Re: *Addendum No. 2*
Woods Ridge Elevated Water Storage Tank
Scioto County Regional Water District No. 1

Date: April 15, 2025

SCIOTO COUNTY REGIONAL WATER DISTRICT NO. 1 WOODS RIDGE ELEVATED STORAGE TANK SCIOTO COUNTY LUCASVILLE, OHIO	SITE IMPROVEMENTS - 01 SERIES	
	WATER STORAGE TANK DETAILS

PROJECT NO.	
241842	
DISCIPLINE	
CIVIL	
SHEET NAME	
01C-04	
SHEET	OF
6	8

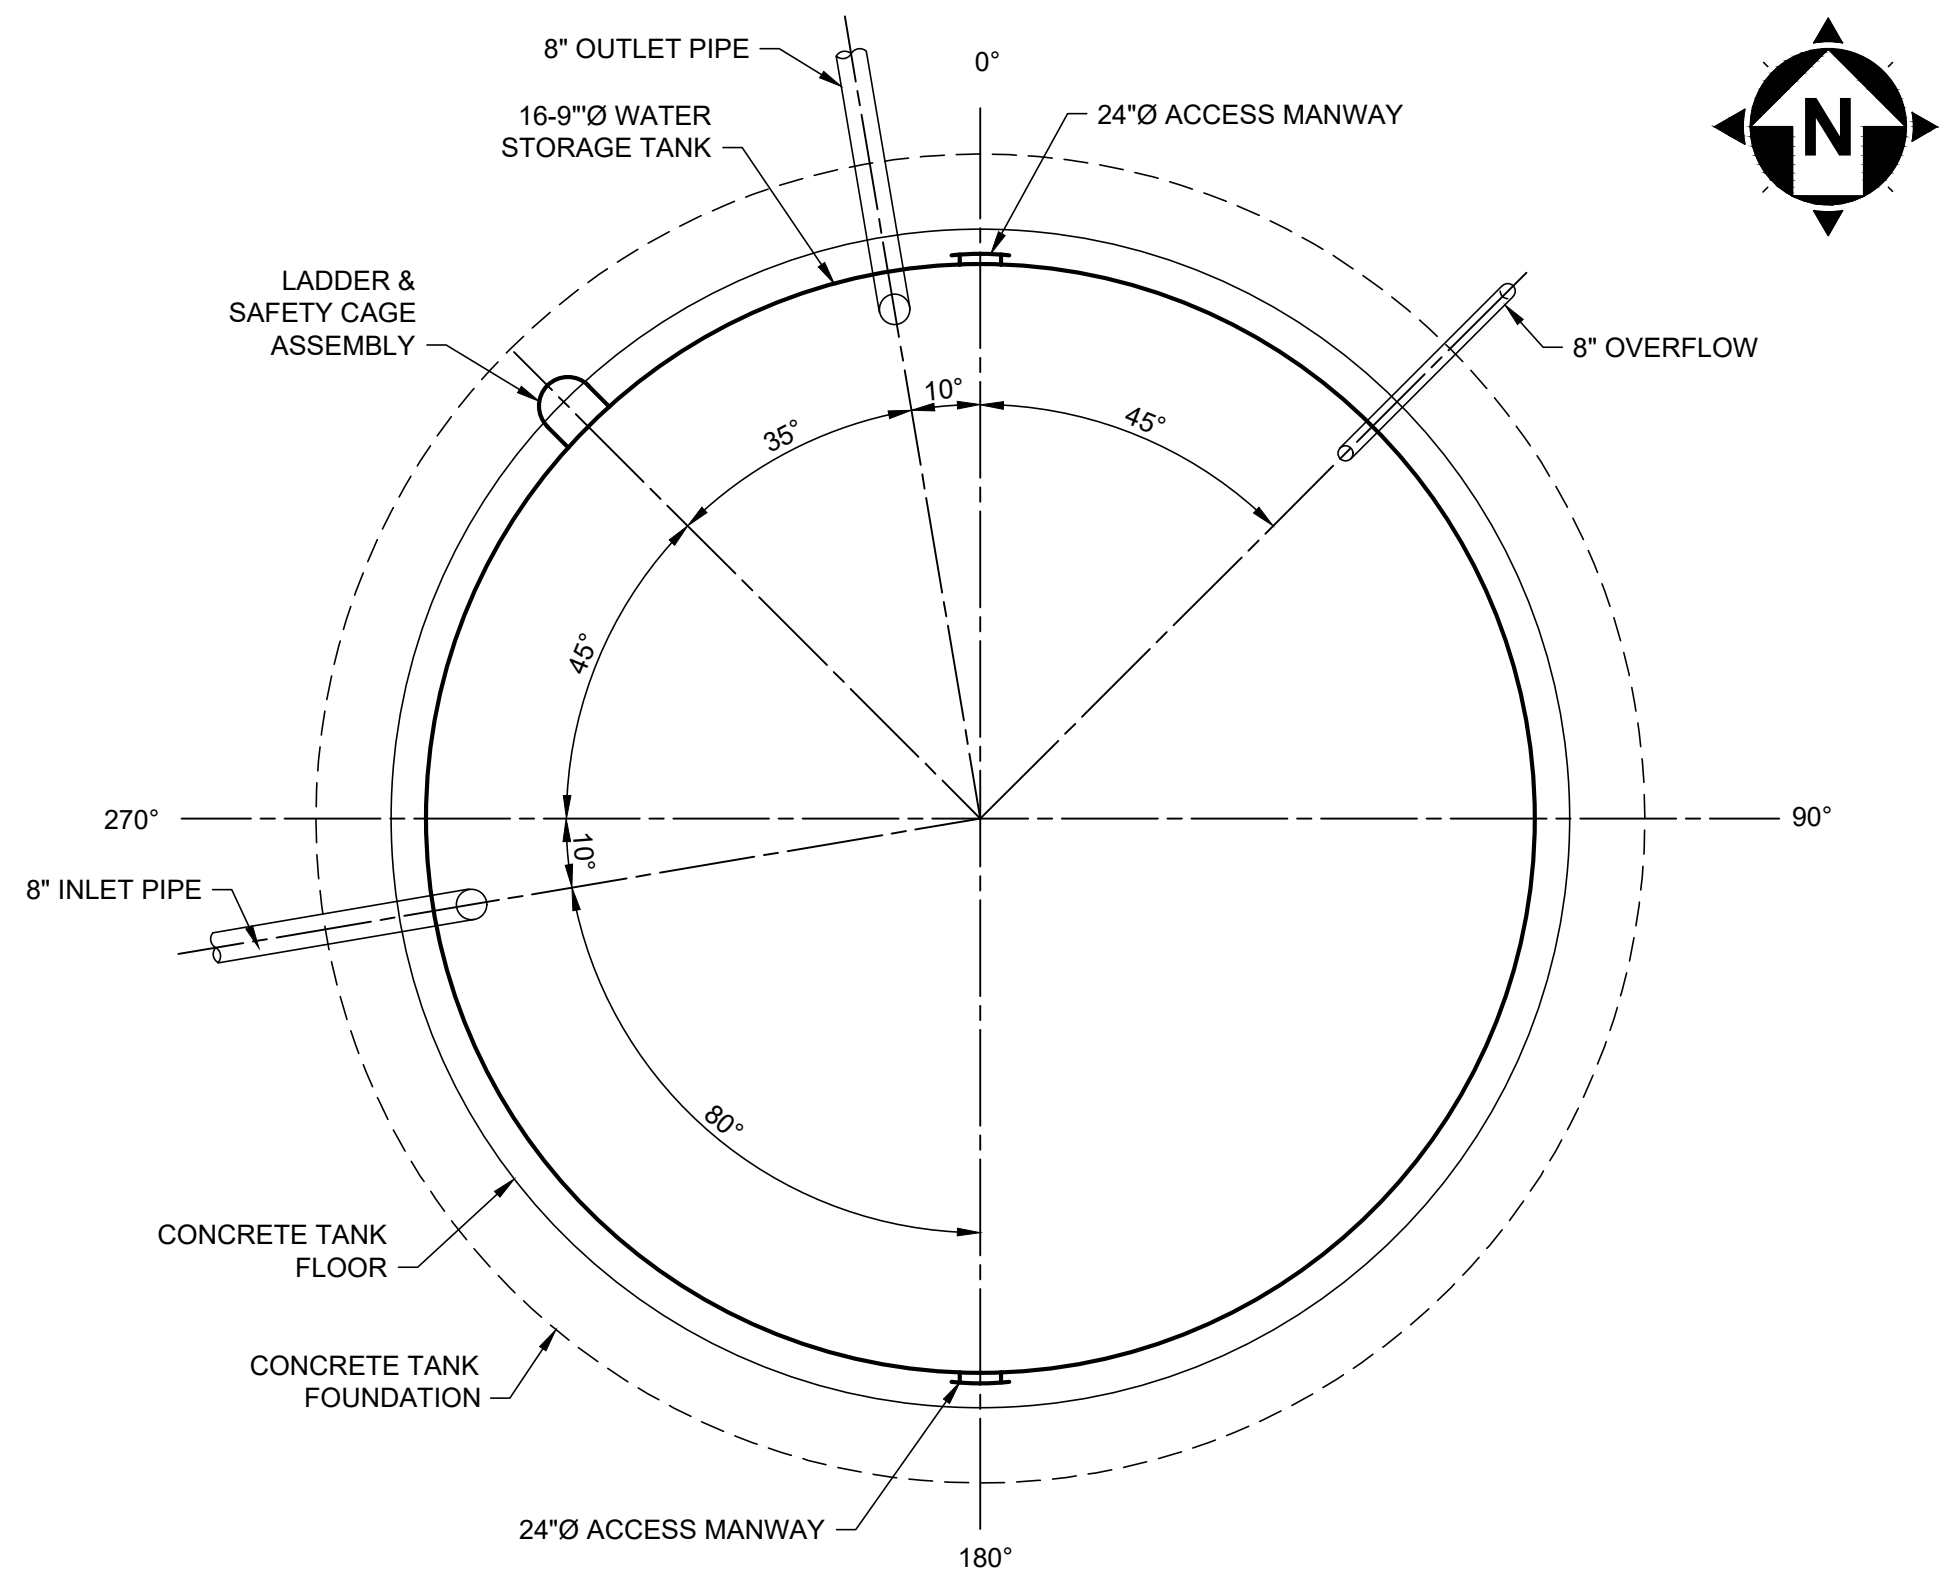
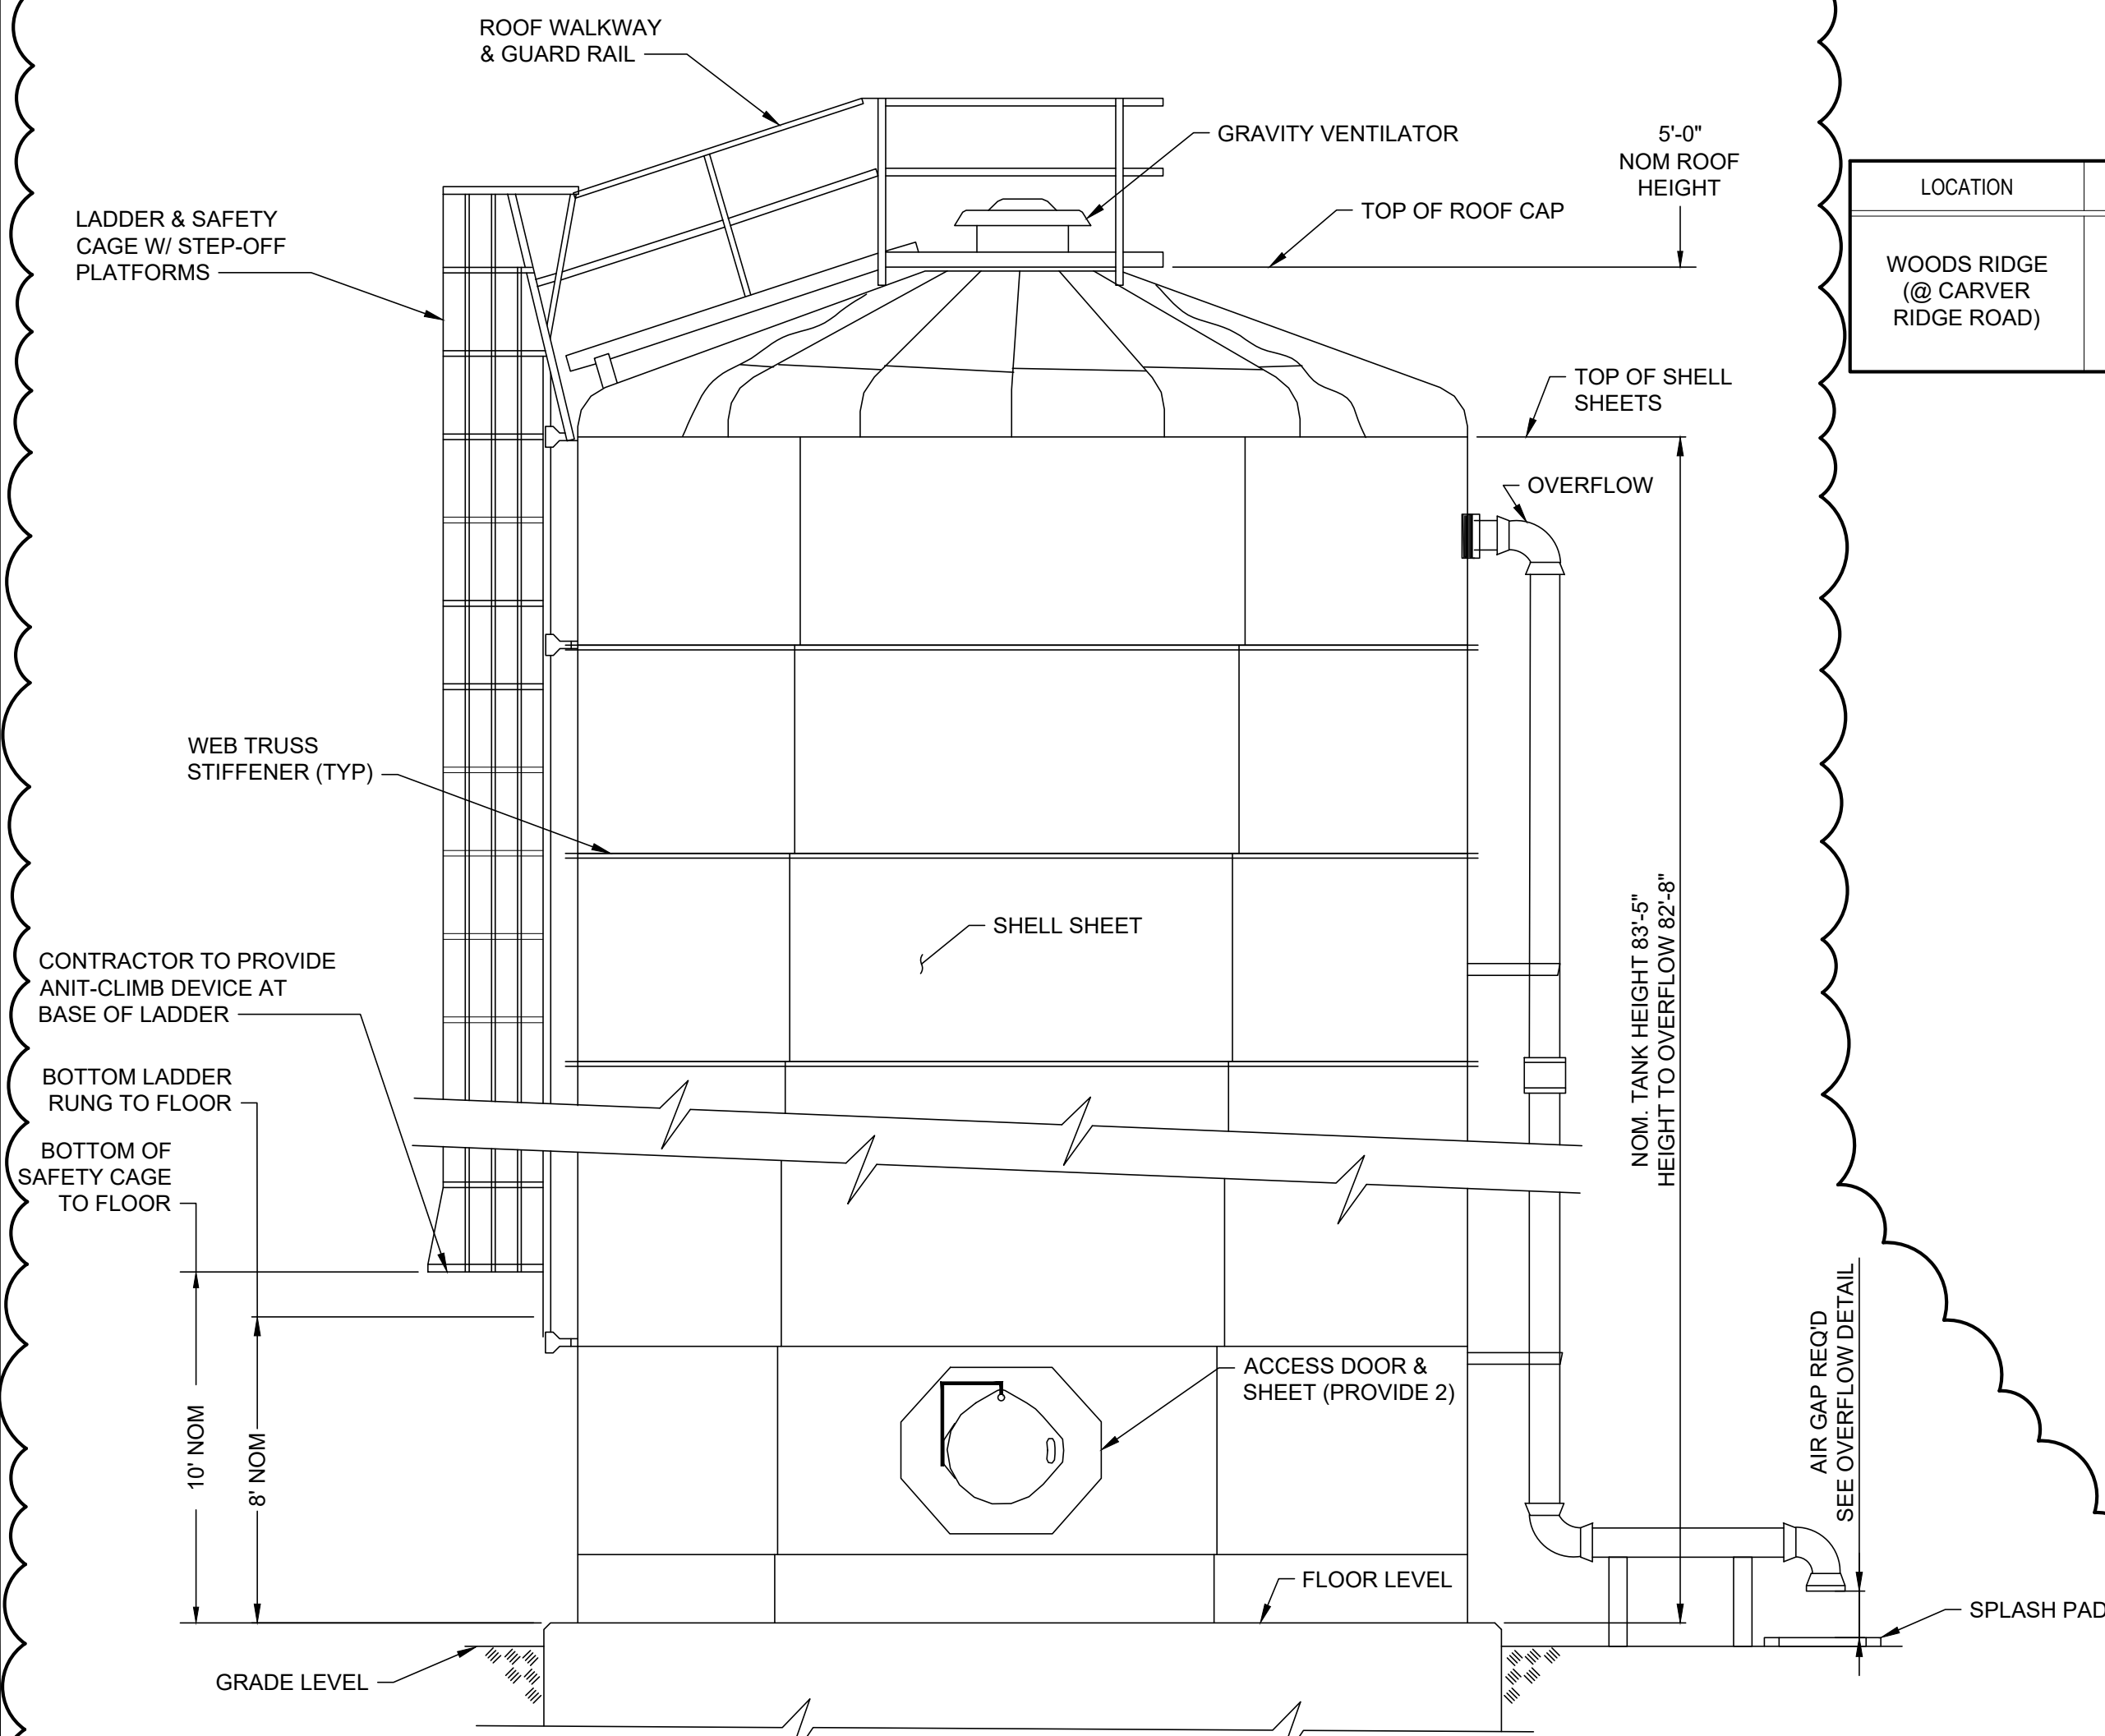
5. SHEET 6 of 8, 01C-04 – WATER STORAGE TANK PLAN & SECTION

REPLACE this drawing in its entirety with the revised drawing attached to this addendum.
